District Response to the Peer Review of the Recommended Minimum Flow for the Rainbow River System

January 2017

Summary Table of Panel Comments Excerpted from the Peer Review of the Recommended Minimum Flow for the Rainbow River System Report and District Staff’s Responses.

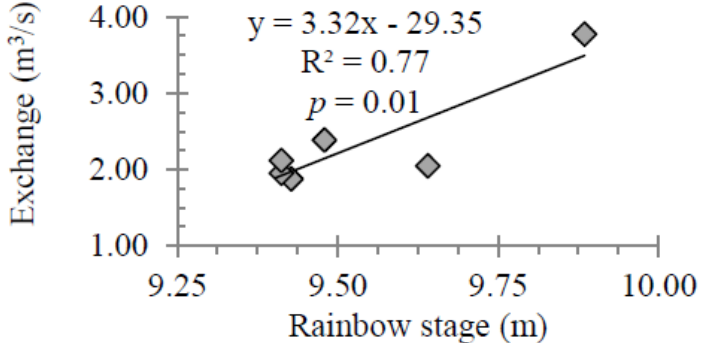
<p>3-4</p>	<p>Specific issues requiring expanded discussion in the report include: 1) <u>Integration of coves (and chlorophyll a) into the MFL</u> A unique feature of the Rainbow River system are old phosphate pits that adjoin the river, and, in some cases receive river water inputs. These coves are potentially important aquatic systems in their own right, and have been shown vulnerable to significant phytoplankton accumulation. Indeed, during the field tour, it was visually clear that return flow from Blue Cove was greatly enhancing chlorophyll a concentration in the river. Research work at UF conducted over the last two years suggests that the coves are a net source of chlorophyll a (though notably <u>not</u> of phosphorus), and that the flow rate into and out of the largest cove, which averages ~2 m³/s (just over 10% of river flow) varies strongly with river stage (fig. 2). Given that mean flow rate, the residence time of water in that cove is nearly 60 hours, more than enough to allow proliferation of a phytoplankton community given high mineral nutrient concentrations in the river water. A decline in river discharge will lengthen the residence time in the cove, and this, in turn, will enhance chlorophyll a concentration in the water returning to the river. Insofar as this is a degradation of water quality, it seems to warrant further consideration.</p>	<p>Page 13, Para. 1</p>	<p>The report will be revised to expand discussion on flow effects on the coves and how these relationships will continue to be studied during the re-evaluation period.</p>

<p>Fig. 2 – Rainbow River stage vs. measured flow rate into Blue Cove (Cohen et al. 2016). The strong positive association suggests that under reduced stage and flow conditions in the river, the water in the coves will be flushed less readily, potentially leading to greater chlorophyll a concentrations and reduced water quality when that cove water returns to the river just downstream.</p>		
3-5	<p>Specific issues requiring expanded discussion in the report include: 2) <u>Algal accumulation</u> The MFL must address a variety of water resource values, and one major ecological change observed in Rainbow River, particularly in the lower reaches, is the accumulation of filamentous algal mats, and the commensurate decline in submerged aquatic vegetation (as well as increased dominance of <i>Hydrilla verticillata</i>, an invasive exotic). While the provenance of these ecological changes is not entirely clear, and likely a response to several overlapping stressors, one emerging theme in the springs literature (e.g. King, 2014) is that flow velocity plays a significant role in algal cover. Where velocities are high, algal cover tends to be low, and while algal cover can vary dramatically at low velocity, proliferation of mats that smother SAV is clearly possible. It was therefore a surprising to see consideration of this algal proliferation issue not mentioned. Given that the link with discharge is direct, it warrants explicit mention in the report, even if the finding is that insufficient data exist to establish the link for this system.</p> <p>Likewise, the loss of SAV is at least anecdotally linked to tubers standing on the bottom and dislodging the plants from flocculent sediments. Because recreation and benthic habitat are both water resource values, it seems relevant to consider this link explicitly.</p>	Page 13, Para. 2	The report will be revised to expand discussion regarding flow effects on filamentous algal mats and recreational-use impacts to submerged aquatic vegetation (SAV) and how these factors will continue to be assessed during the re-evaluation period.
